**From:** [William Hodgkinson](#)  
**To:** [Andrew Cowan](#)  
**Cc:** [Sheelagh Laguna](#); [Bianca Thornton](#); [Travis Lythall](#); [Stephen O'Connor](#); [Paul Solomon](#)  
**Subject:** SSD 9667 Kemps Creek Warehouse, Logistics and Industrial Facilities Hub  
**Date:** Friday, 23 August 2019 4:15:00 PM  
**Attachments:** [Peer Review.pdf](#)

# **Mamre South Precinct Peer Review of the Overland Flow Report Stage 1 (Rev A)**

**Project: Mamre South Precinct, Mamre Road, Kemps Creek**  
**Peer Review of the Overland Flow Report Stage 1 (Rev A)**

**Figure 6 Comparison of post-development TUFLOW terrain and DA design RLs**

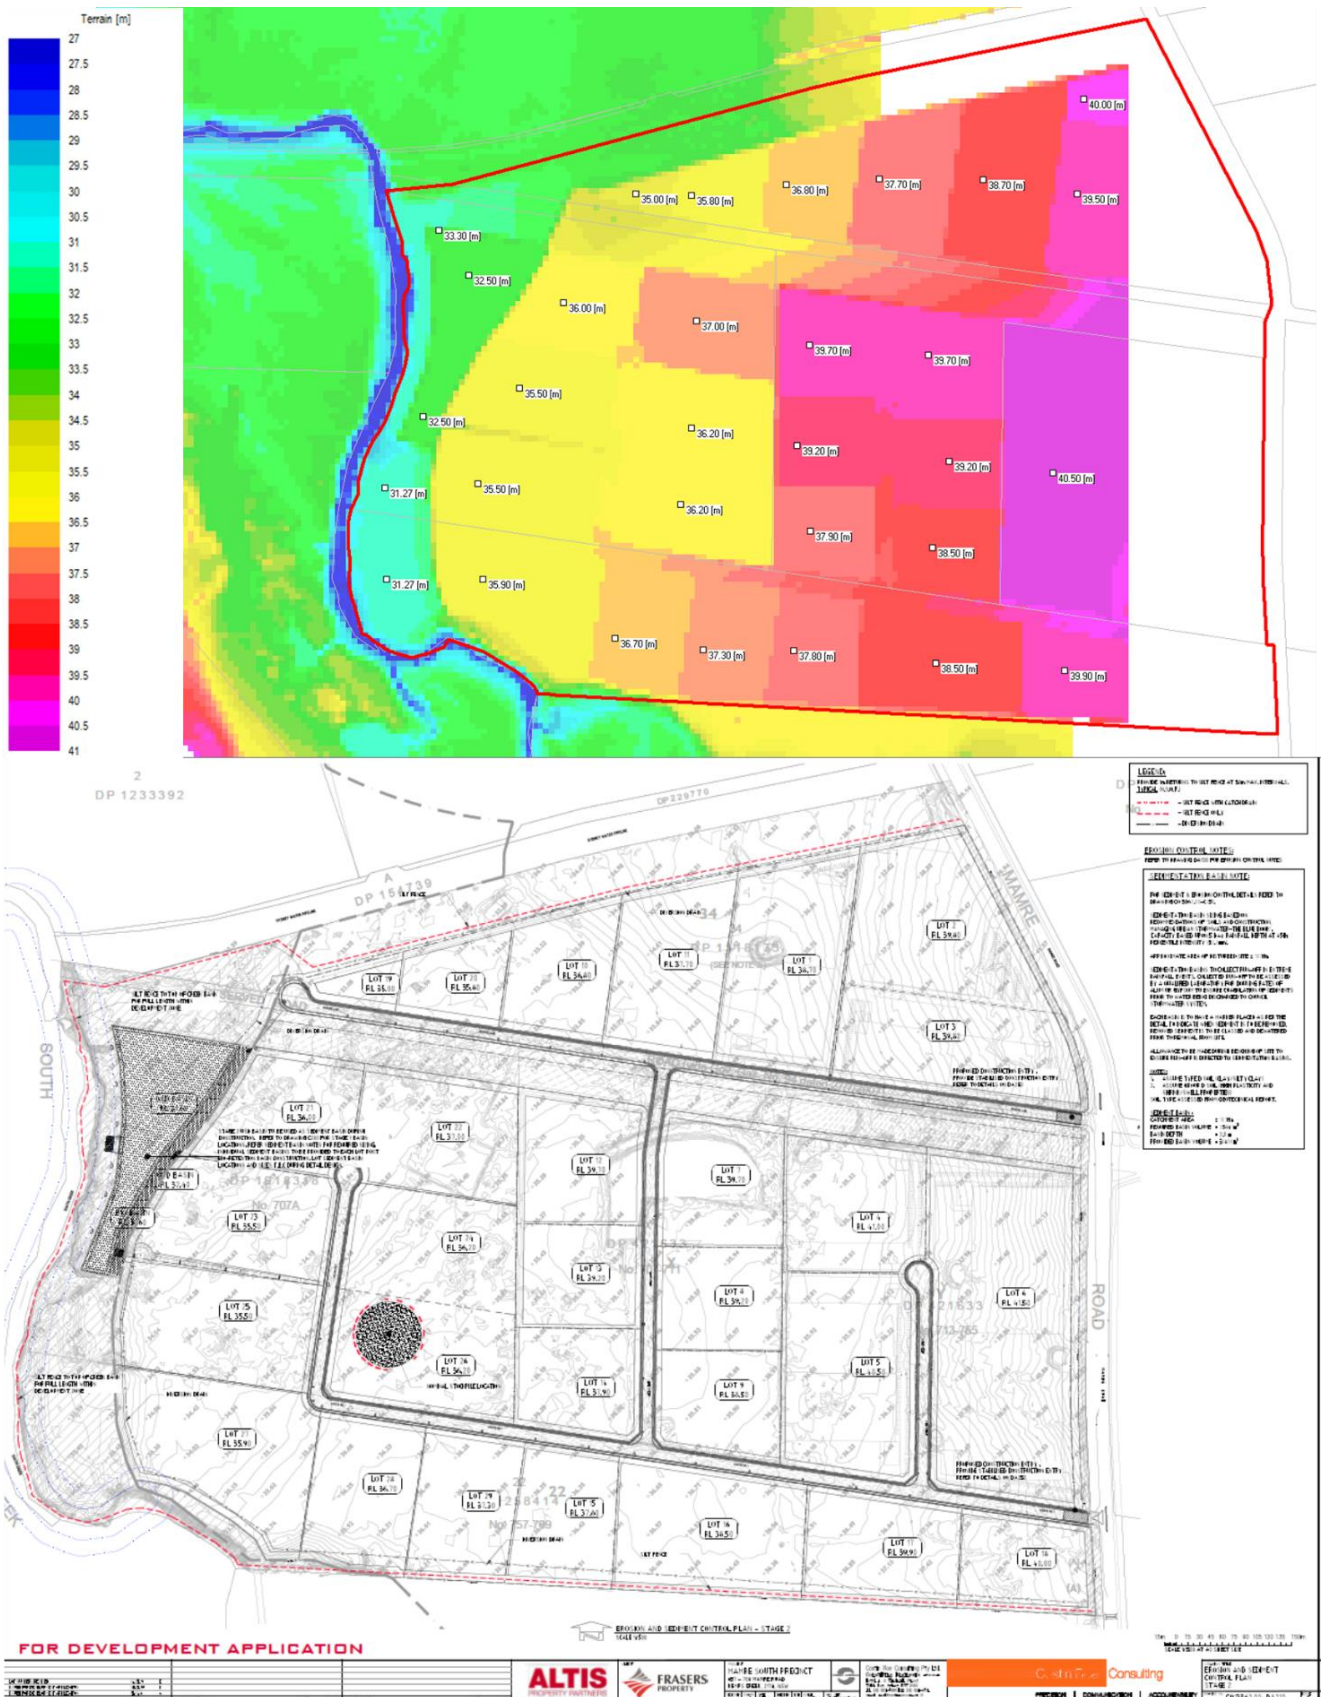
- Model ground elevations across the proposed lots generally match those indicated on the Stage 2 Erosion and Sediment Control Plan submitted for the Development Application (*Drawing No. C013362.00-DA210*)

- The only exceptions to the above were Lot 2 (*model elevation 40.0 mAHD rather than 39.8 mAHD*) and Lot 3 (*model elevation 39.5 mAHD rather than 39.8 mAHD*). These lots are outside of the simulated PMF extent.

**Figure 7 1% AEP peak flood velocities across South Creek near upstream site boundary**

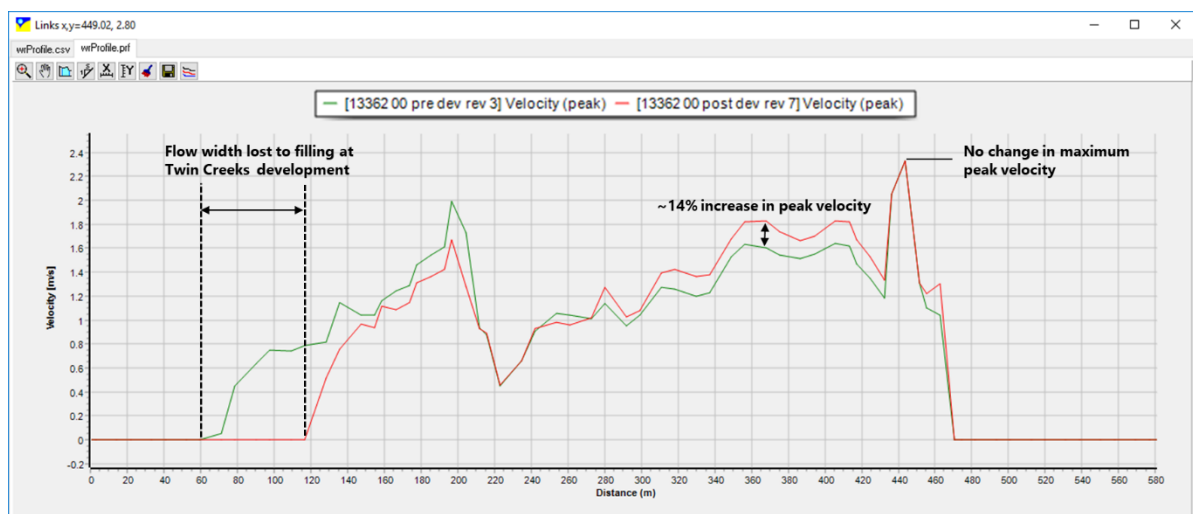
- Peak velocities across a section of South Creek where the 14% increase occurs are presented in **Figure 7**. The velocity profile suggests that velocity increases may be predominantly caused by filling of the floodplain at Medinah Avenue in the Twin Creeks development and the associated redistribution of flows. There was no increase in the maximum peak velocity across the section.

- The extent of velocity increases greater than 10% is limited,
- No increase is expected in the maximum peak velocity across the creek channel section at the location of the 14% increase (*refer Figure 7*)
- A significant proportion of the velocity increase may be attributable to filling on the western side of the floodplain associated with the Twin Creeks development. Recommendations to resolve the impact directly attributable to the proposed Mamre South Precinct development are presented in **Table 2** under **Finding A7**.

**Figure 10** Reproduction of Overland Flow Report Appendix C figure showing fill within floodway

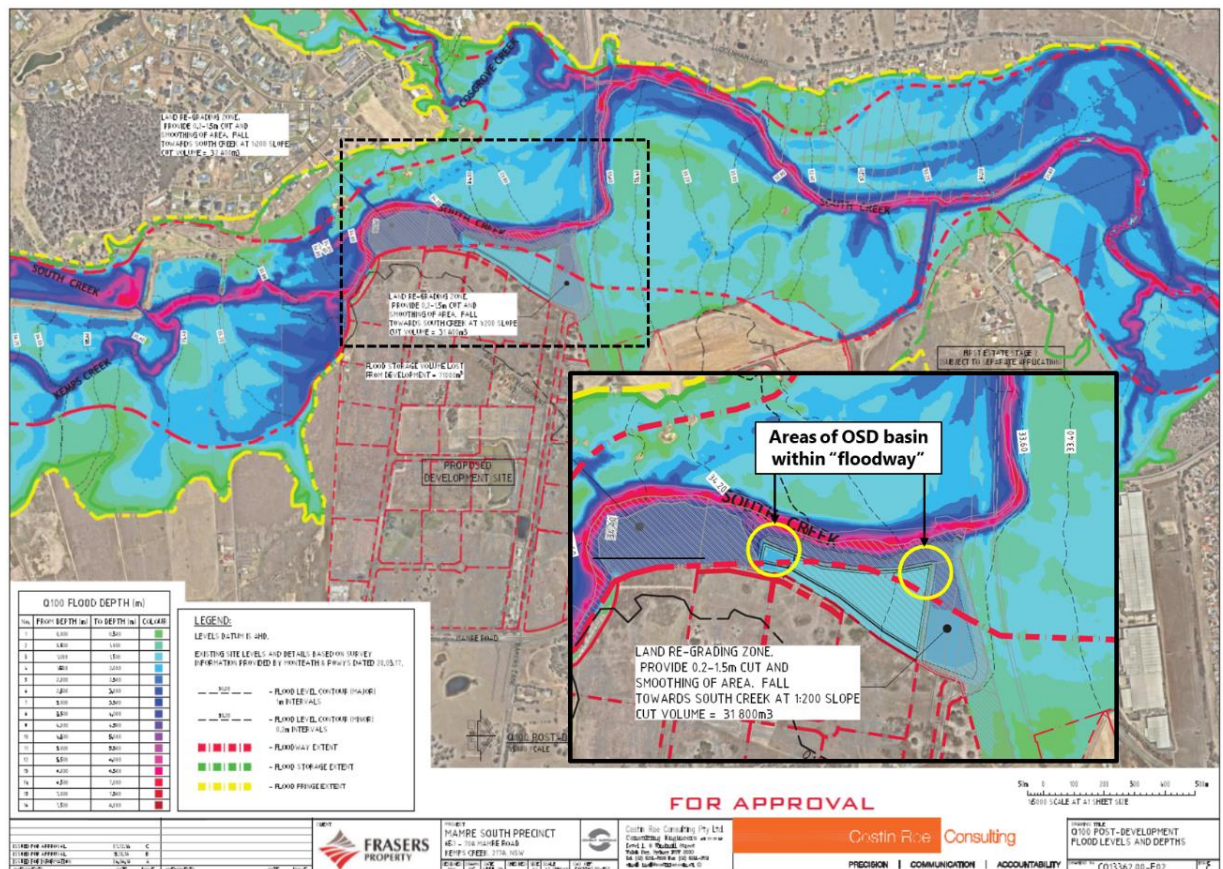
Parts of the proposed OSD basin are located within areas that are designated as both "floodway" and "high hazard". This is clearly indicated in the Overland Flow Report, Appendix C, Drawing No. C013362.00-F02, as reproduced in **Figure 10**.

The embankments of the proposed basin would raise the topography above the existing level, obstruct flood flows and potentially reduce flood storage. Accordingly, this would be considered filling of a floodway area and would not be permitted under the DCP (**Finding A8**).

As this first criterion is not met, it is understood that the proposed development in its current form would not be permitted. Accordingly, the following merits-based criteria (i to ix) do not apply, but have been assessed nonetheless to assist in any subsequent refinements of the proposed development from a flooding perspective.

**Figure 11 Proposed cut affecting area of riparian vegetation**

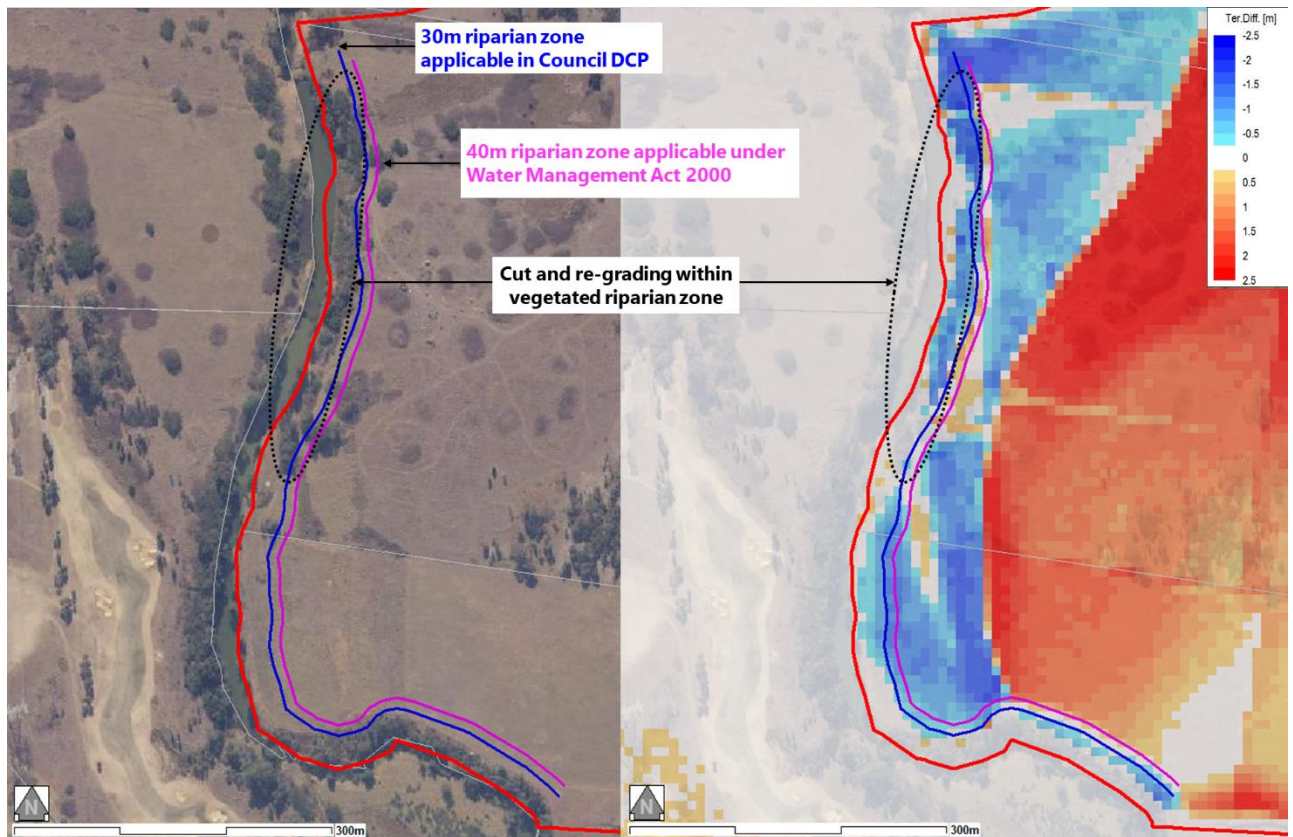
Notwithstanding, cut and re-grading works are proposed to offset the loss of flood storage associated with the proposed filling. As shown in **Figure 11**, the proposed areas of cut and re-grading include a significant area of riparian vegetation. While the works affecting the vegetation do not technically constitute “filling”, it is evident that these trees would be affected by the proposed development and it is not clear why this criterion would not be applicable (**Finding A12**).

**Figure 12 Reproduction of Mamre South DCP Site Opportunities and Constraints Map**

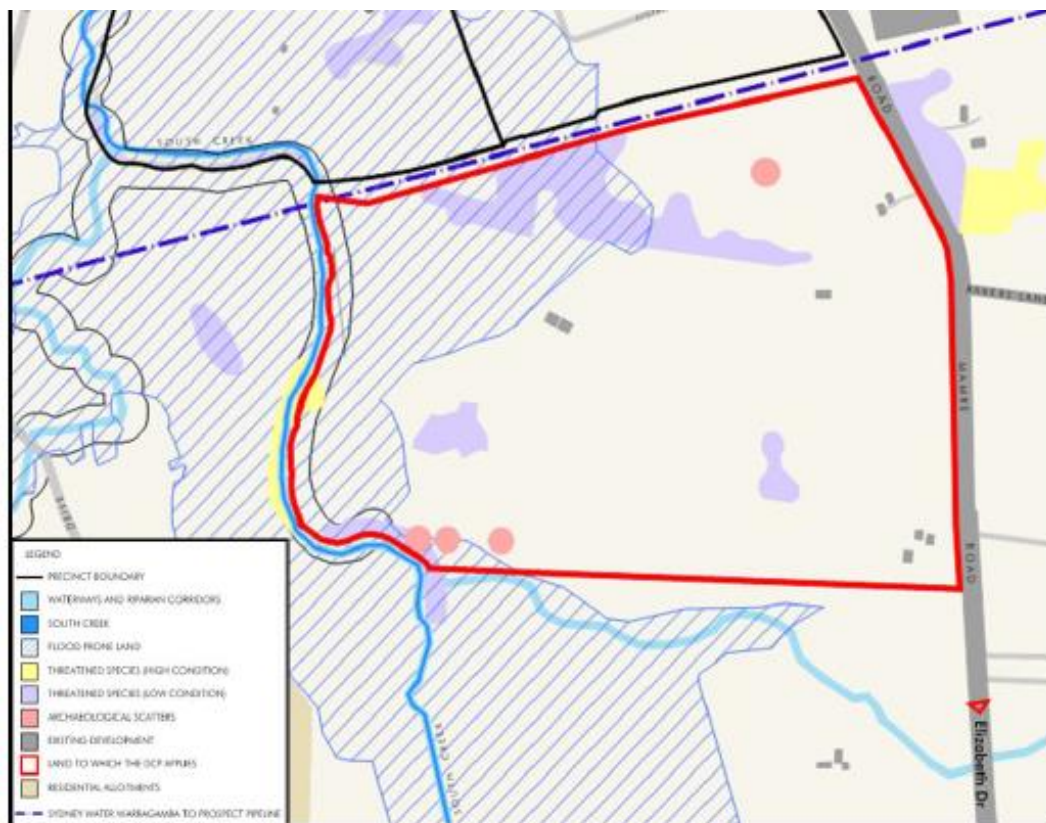
- Figure 2 of the Mamre South DCP (2019) shows site constraints which includes the presence of land classified as 'Threatened Species (High Condition)' within the riparian corridor of the site (refer **Figure 12**). The proposed development should consider any additional requirements that arise from this (**Finding A15**).

**Figure 13 Reproduction of Mamre South DCP Access Strategy**

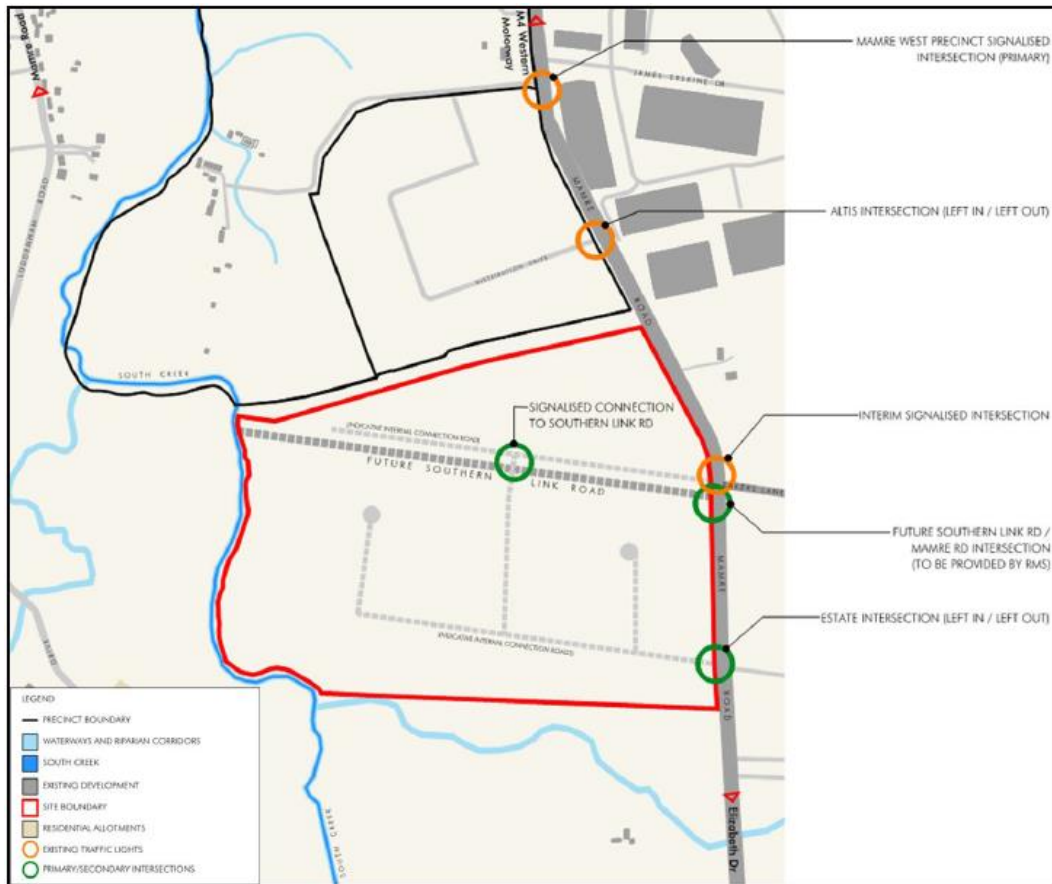
- Figure 5 of the Mamre South DCP (2019) shows that the "Future Southern Line Road" passes through the site (refer **Figure 13**). Similarly, a possible future freight rail corridor passes along the northern boundary of the site. The proposed development includes cut and re-grading within the possible future freight rail corridor and road reserve, and this cut volume is used to offset flood storage lost to filling of the site. For this cut area to be considered as an offset to lost flood storage, Council and/or DPIE would need to be confident that the provided volume would not later be lost associated with any future freight rail or Southern Line Road development (**Finding A16**).
